CITY OF ALBUQUERQUE

Re: Approval of Permanent Certificate of Occupancy (C.O.) for

Thomas Bell Community Center, [M-15 / D030]

Re: Thomas Bell Community Center Grades at Handicap Parking

PARTAL SITE PLAN

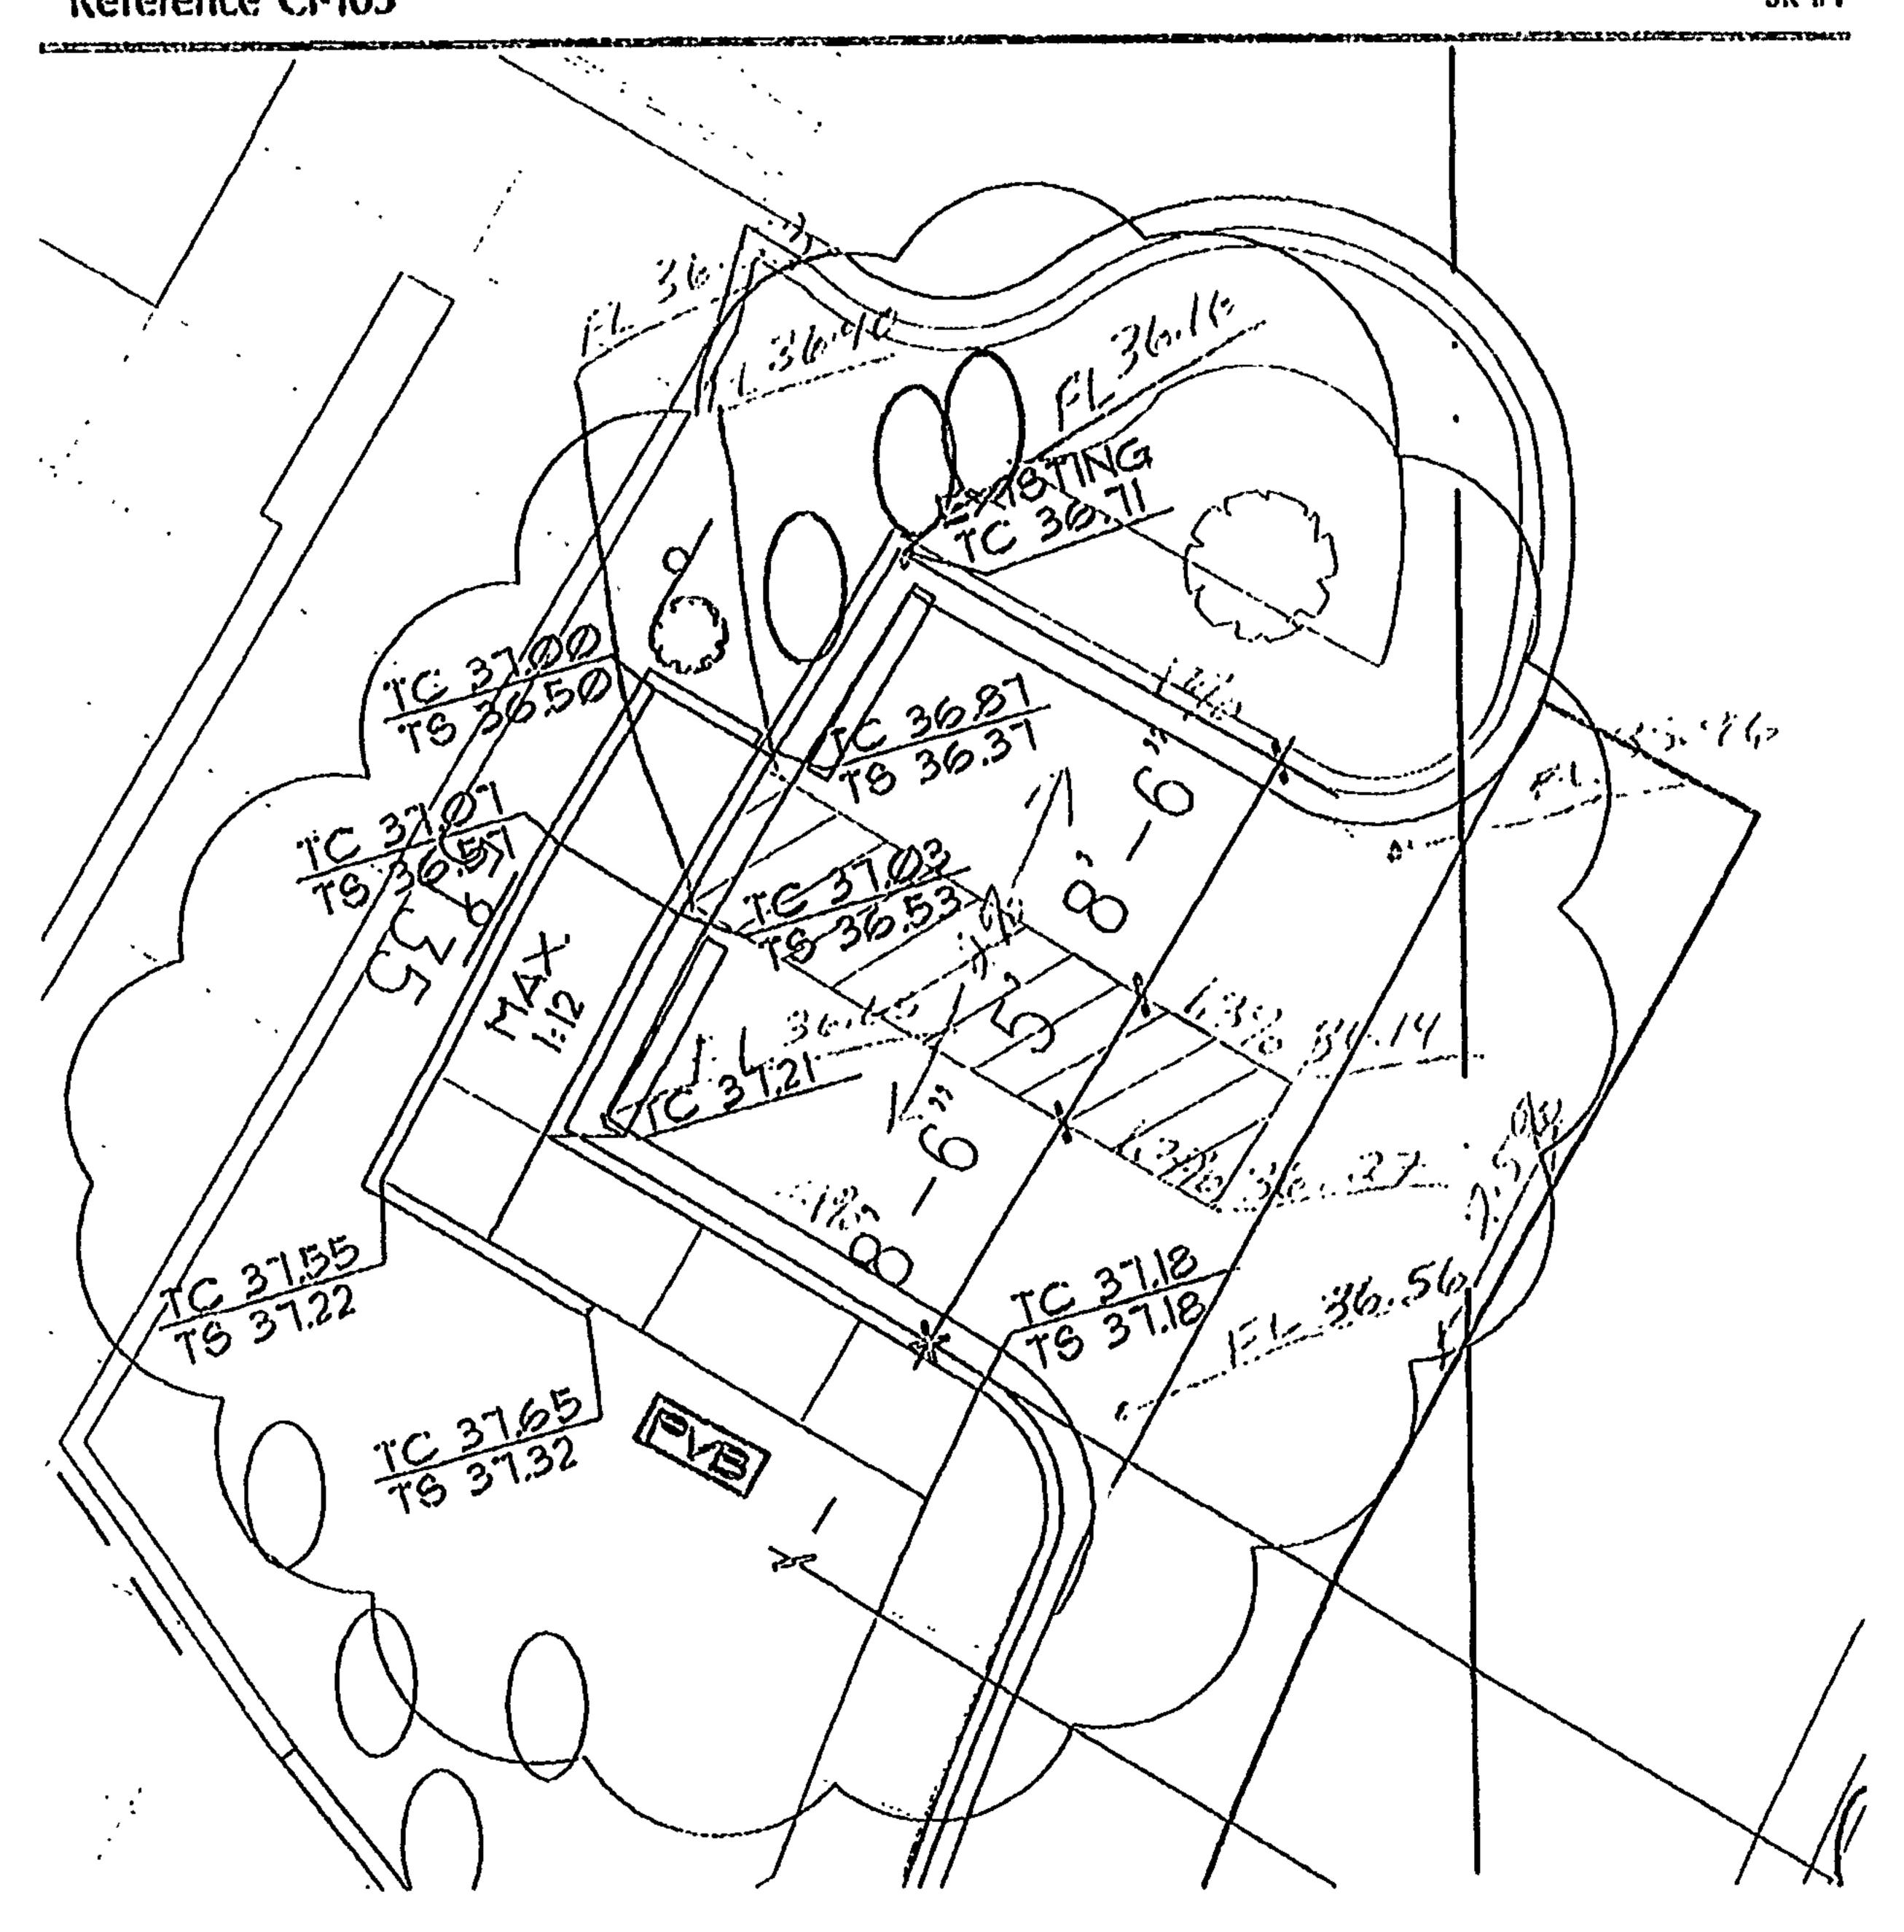
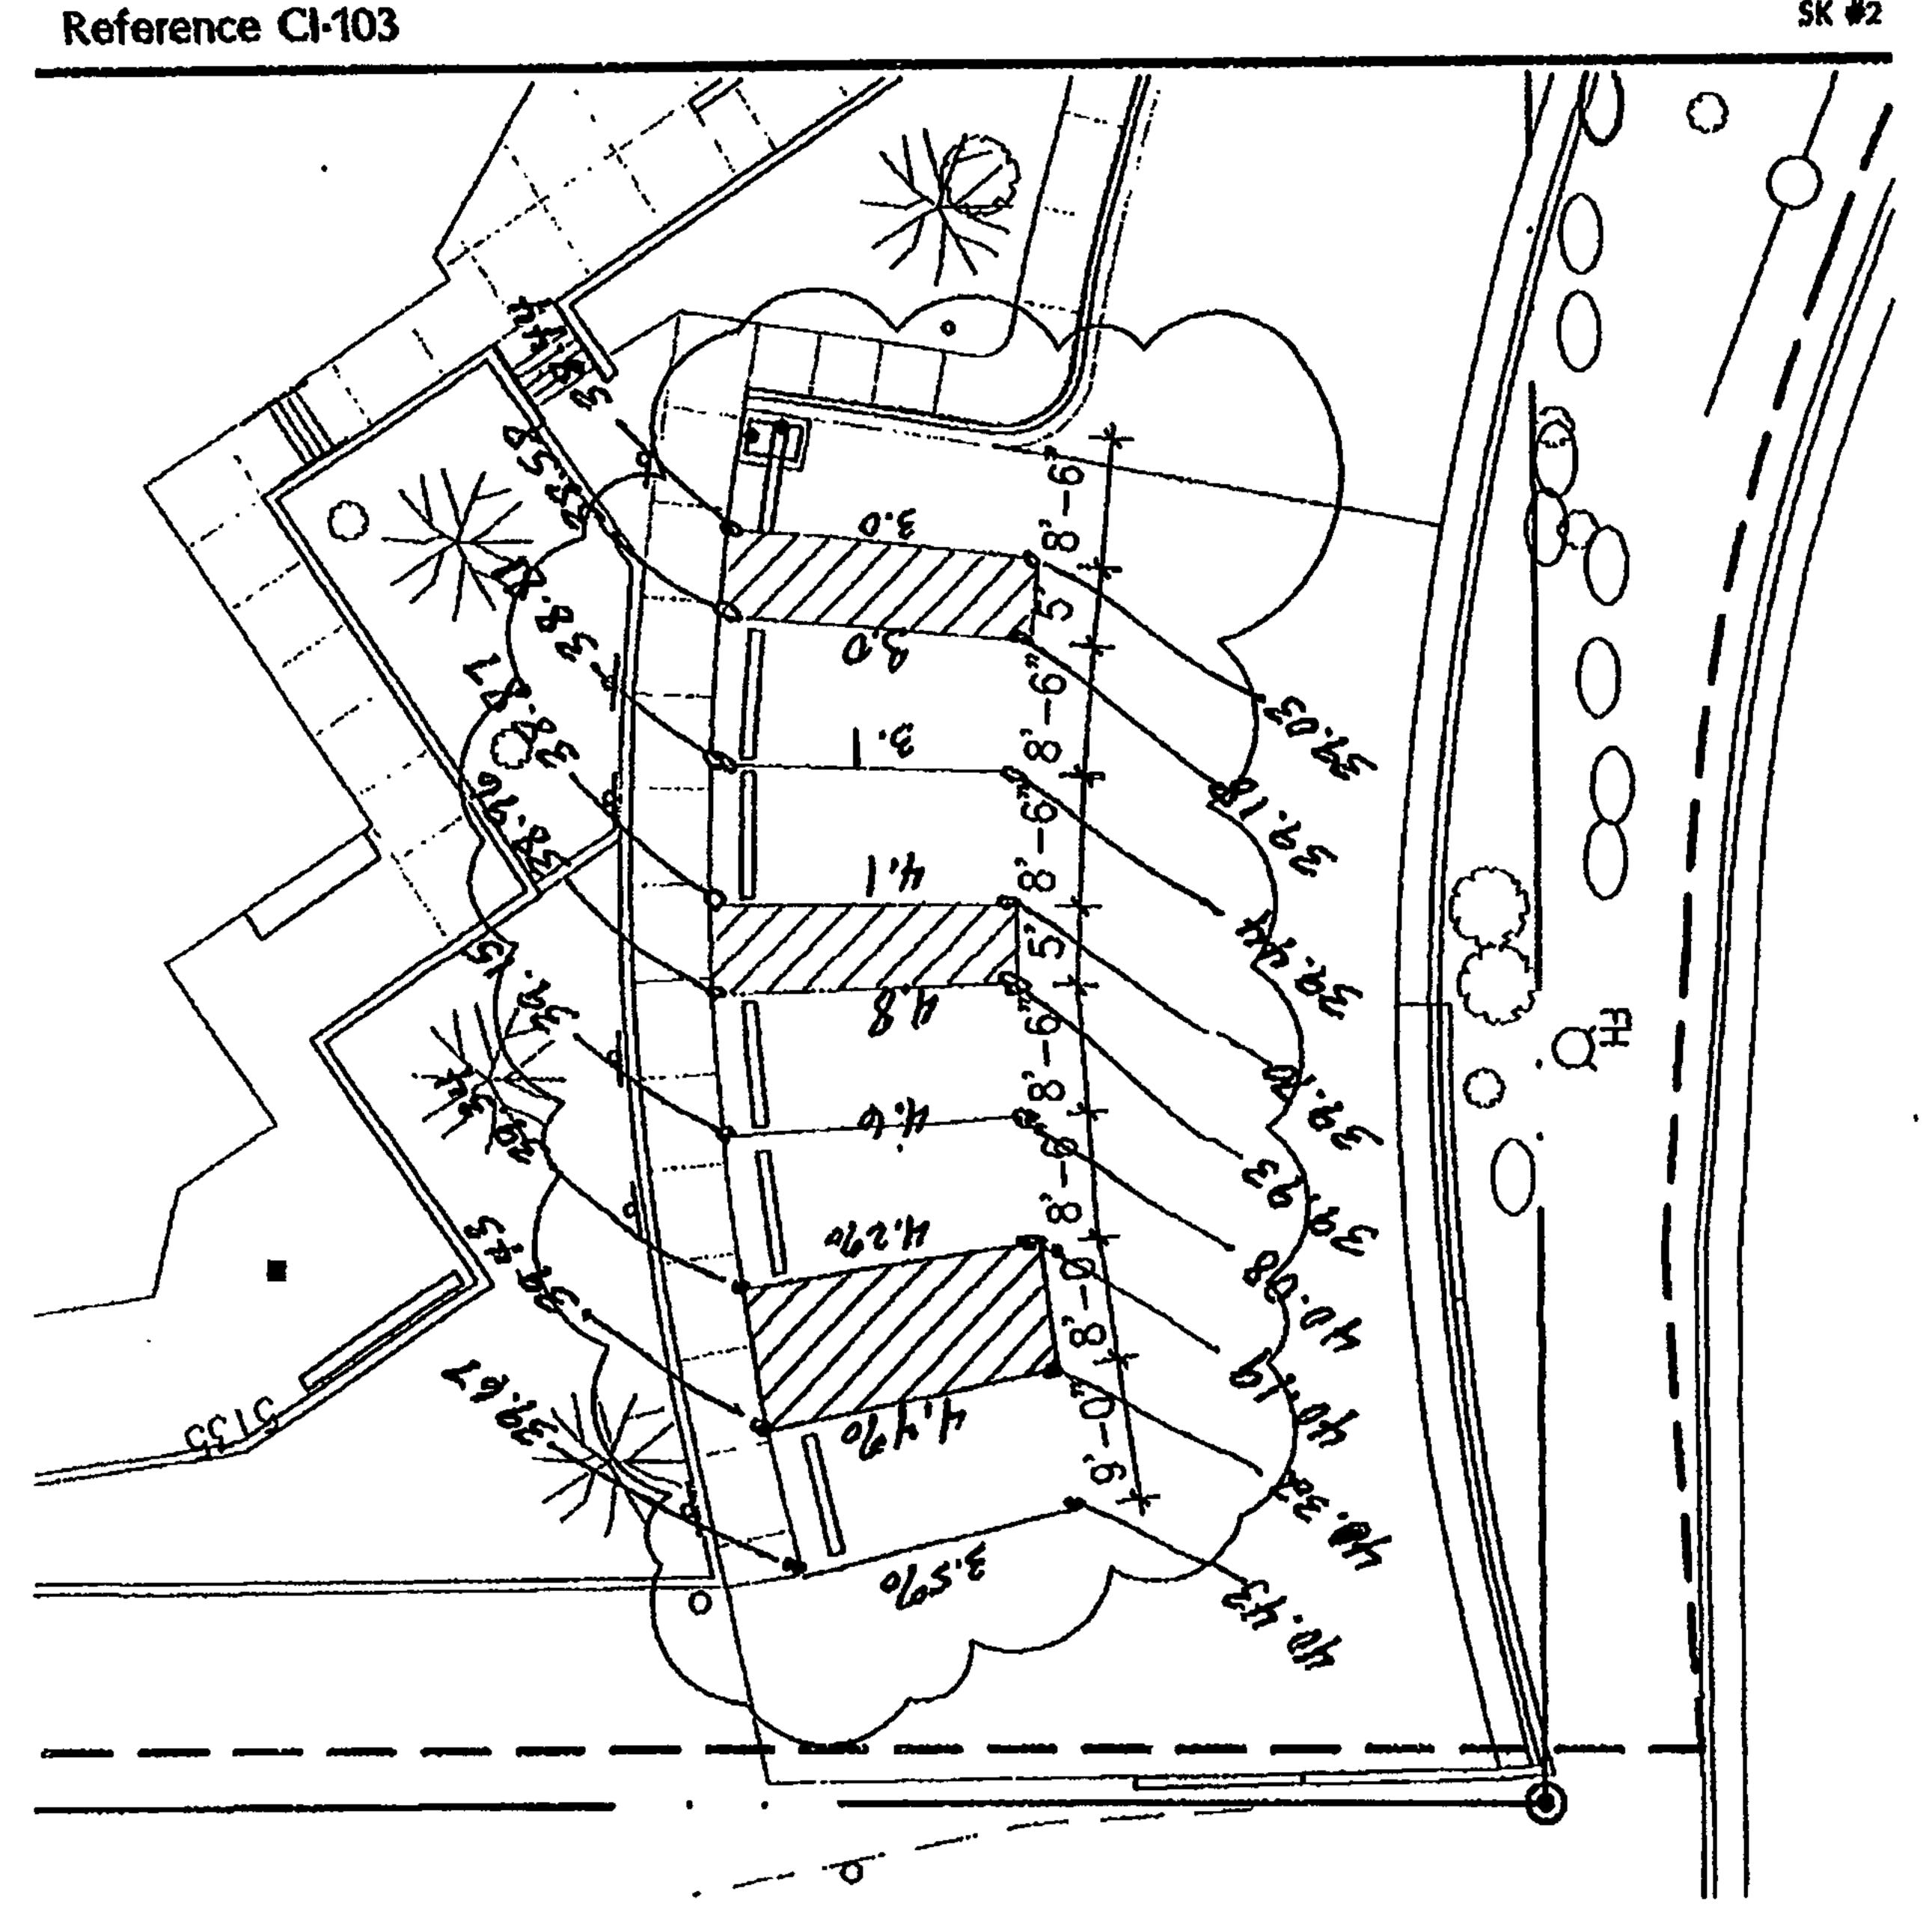
As mentioned in the previous emails from Graeme Means, High Mesa Consulting Group, the grades at the handicap parking lots exceed the 2% slope required by ADA. As you will recall, the site is on a steep hill and the closest existing "level" parking was immediately to the east of front door. After the expansion of the facility, additional handicap parking spaces were required. We proposed using all the parking spaces to the east of the building for this purpose. The existing grades did not meet the 2% slope at that time. Our plans proposed regrading the parking lot and adjacent drive to meet the 2% requirement. During construction and the regrade, we discovered a buried gas line and telephone line preventing us from going the full depth required. The contractor lowered the grade as far as he could, without moving the utilities at great expense to the Owner and managed to meet the existing grades and flatten the parking to meet ADA in some, but not all areas. The steepest cross slope at the handicap parking is 4.8% in one area. See attached grades from the contractor.

NOTE: THESE ARE REGULAR HANDICAP SPACES, PROVIDE APPROPRIATE SIGNAGE.

NOTE: HANDICAP PARKING SPACES ARE 8'-6" NOW INSTEAD OF 8'-0" AND VAN ACCESSIBLE SPACE IS 9'-0" WITH 8'-0" AISLE AT SOUTH END. COORDINATE APPROPRIATE SIGNAGE ACCORDING TO SPACES.
